Amendment of Solicitation

Solicitation No. 26-FM-0010

Amendment No. 2

Stillwater Res/OSU Multi-Purpose
Solicitation 26-FM-0010

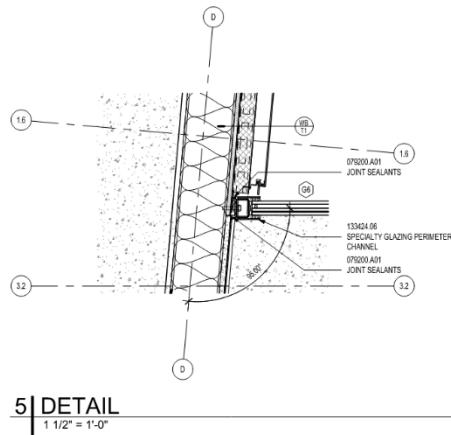
Q 49: For the north wall, the drawings appear to be missing some structure. See below snip from sheet A2.0. We will need to add structure at the clouded locations. Can you confirm that this is acceptable?

A 49: Confirmed, additional fins can be provided at the edges of the glass. It is also acceptable to provide a freestanding portal at the door. Refer updated drawings in upcoming addendum.

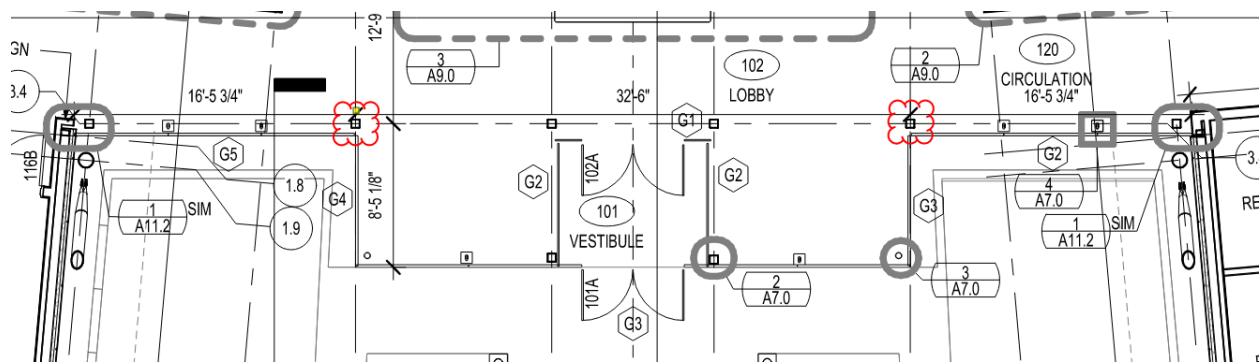
Q 50: Can you confirm that no additional steel is needed at the jambs of the north wall? Is the wall material shown structurally sufficient to support the glazing system channels? Ref. detail 5/A7.0 (below).

A 50: See upcoming addendum.

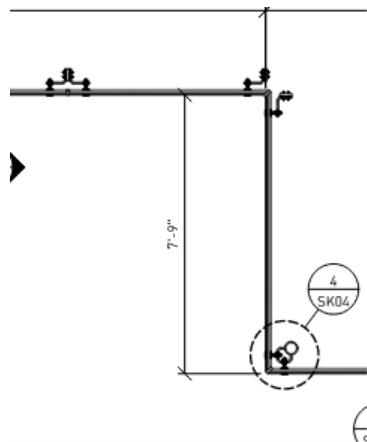
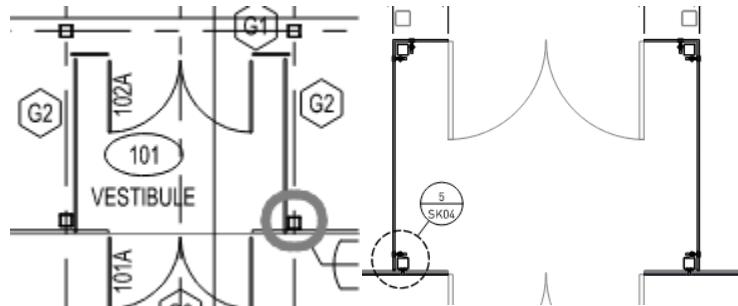
Q 51: At the clouded locations on A2.0, below, the drawings show no steel fins and instead just have structural columns (by others). In previous pricing estimates, Novum had been including (2) steel fins at each corner. See second snip below. It may be cleaner to have at least one steel fin at this location rather than trying to have extended glazing arms coming off the steel by others to pick up both lites of glass. Is it acceptable to do so, or should we develop a solution with custom glazing arms that attach to the HSS column?

A 51: See upcoming addendum.
